# Mount Rawdon Operations Northern Waste Rock Dump Detailed Cover System Design: Concept Study Review Report

31 May 2024

Evolution Mining Pty Ltd (Evolution) have requested O’Kane Consultants Pty Ltd (Okane) produce a Concept Study Review Report with respect to the Northern Waste Rock Dump (NWRD) located at the Mount Rawdon Gold Mine Operation (MRO). MRO is located 270 km north-west of Brisbane and 70 km south-west of Bundaberg, Queensland.

The objective is to determine if there is sufficient data to develop a detailed cover system design for the NWRD. The cover system will support the regulatory requirements contained within Section 3.6.1 of the Progressive Rehabilitation and Closure Plan (PRCP) Guideline by specifically addressing the requirements to ensure a low residual risk of acid and metalliferous drainage (AMD)<sup>1</sup> at the NWRD.

Figure 2.1: a.) Key site features at MRO, and b.) key features of the NWRD (Google Earth, 2023).

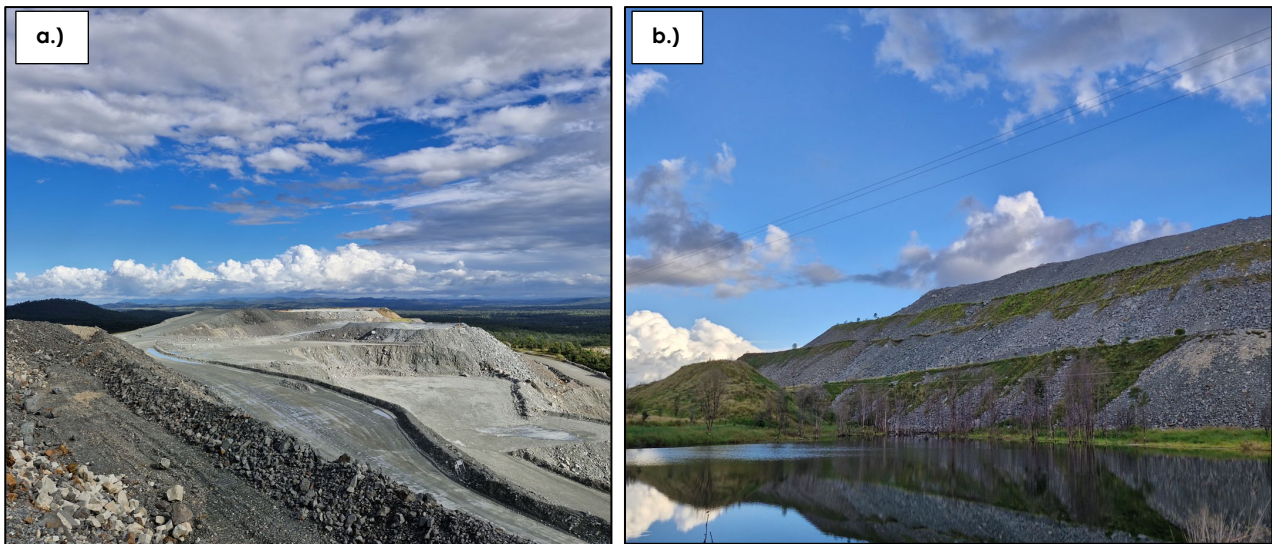
- It is worth noting that based on the assessed aerial survey, a local failure of the berms in the northern section of the NWRD has been observed. Its location is detailed in Figure 2.1b. However, details regarding the nature of the failure have not been documented in the received reports or been provided anecdotally.

**Figure 3.33: Preferred cover system outcome design for the NWRD (RGS, 2022).**

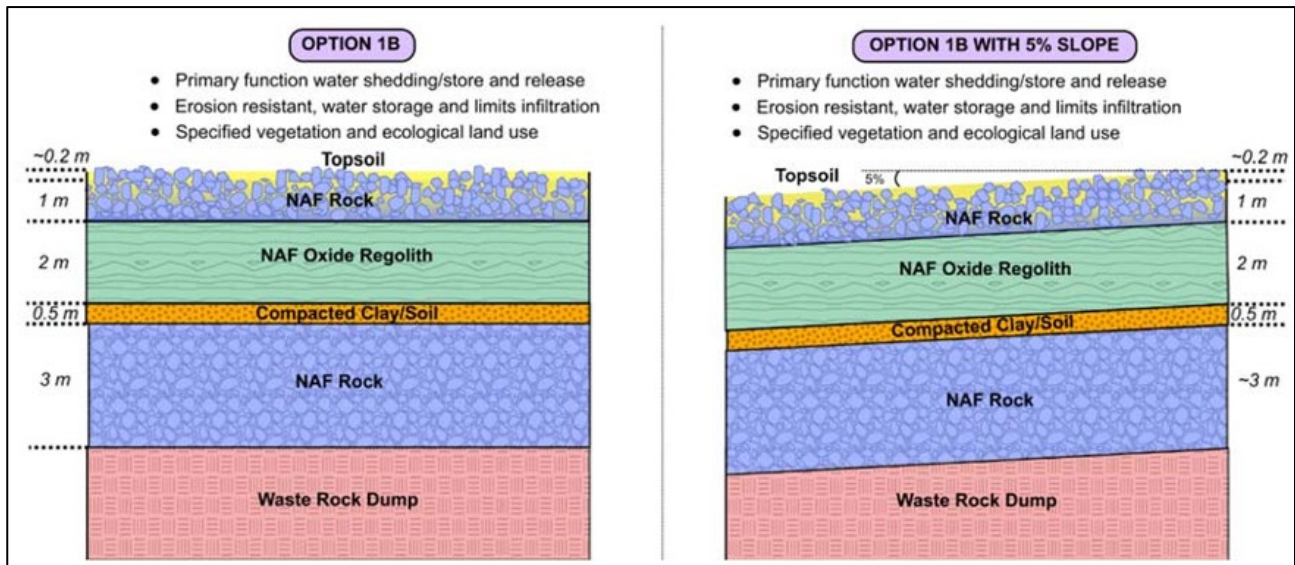
Information gaps have been identified in the cover modelling design methodology with respect to appropriate timeframe for design rainfall events. The key points highlighting the identified information gaps and their implications are:

- The current cover modelling design does not factor in the potential impacts of climate change, which could lead to an underestimation of erosion and infiltration rates due to more frequent and intense weather events.

- Storm events were modelled with a 10-year recurrence for infiltration, which may not accurately reflect the increasing intensity and frequency of storms in the closure timeframes.

- Erosion modelling used a 100-year annual exceedance probability (AEP) which potentially overlooks extreme climate patterns and longer closure timeframes. The previous hydraulic assessment recommended a 0.1 % AEP (ATC Williams, 2014).

- Erosion flume tests exclude rock particles larger than 75 mm, and geotechnical labs use smaller particle sizes for certain measurements. This introduces uncertainty in results, potentially impacting erosion predictions.

Figure 3.55: Modelled annual erosion rates for as-placed material with a 5% slope angle and slope lengths from 10 m to 110 m (RGS, 2023a).

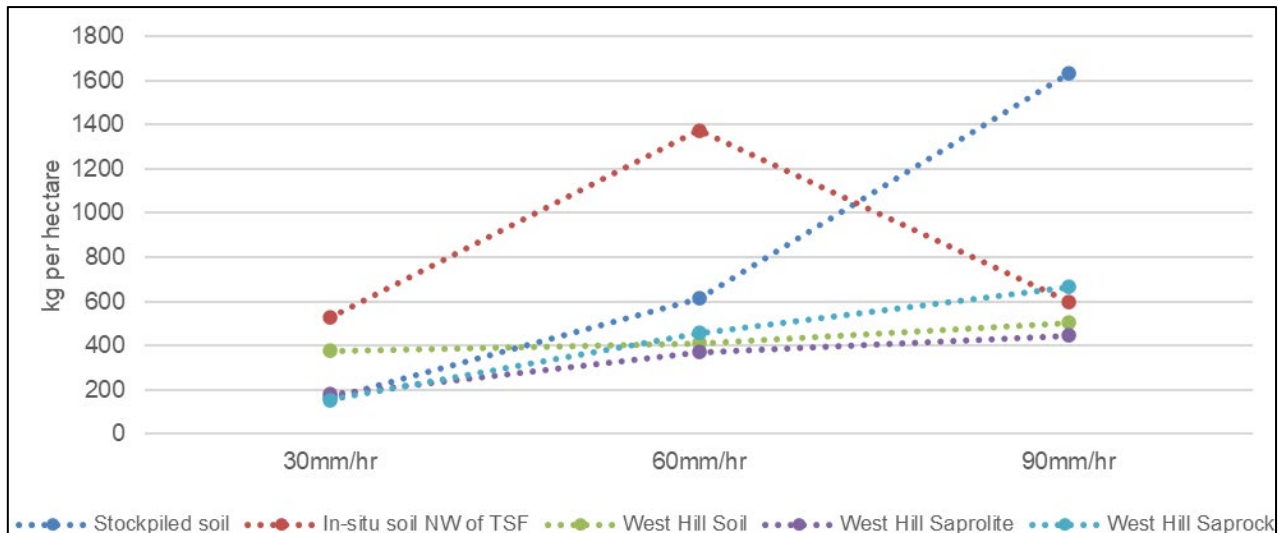
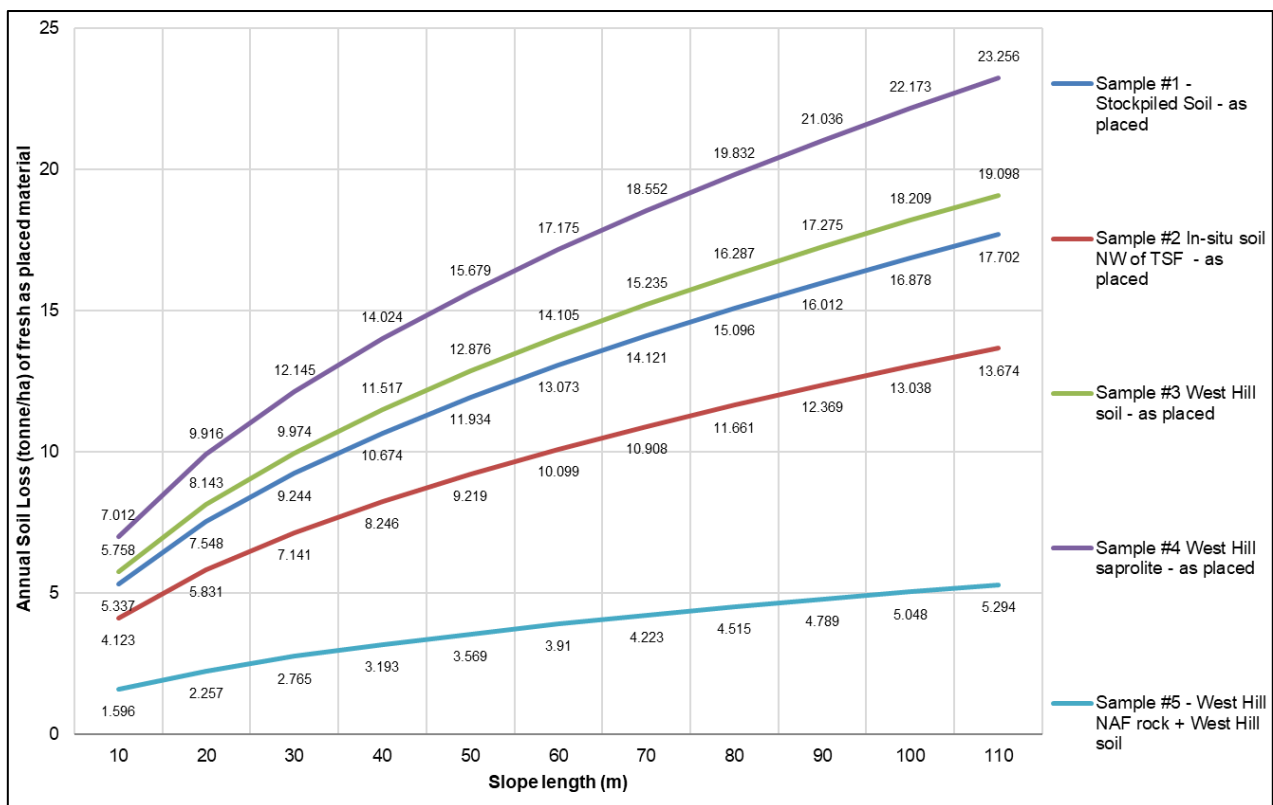
- Cover field trials have the potential to calibrate flume testing. To Okane's knowledge these field trials have not been conducted, however it is understood that vegetation/cover trials may be undertaken by ATC Williams to support a TSF cover system design in 2024. Erosion measurements are not included in the planned monitoring system for the cover trial however would be a useful inclusion.
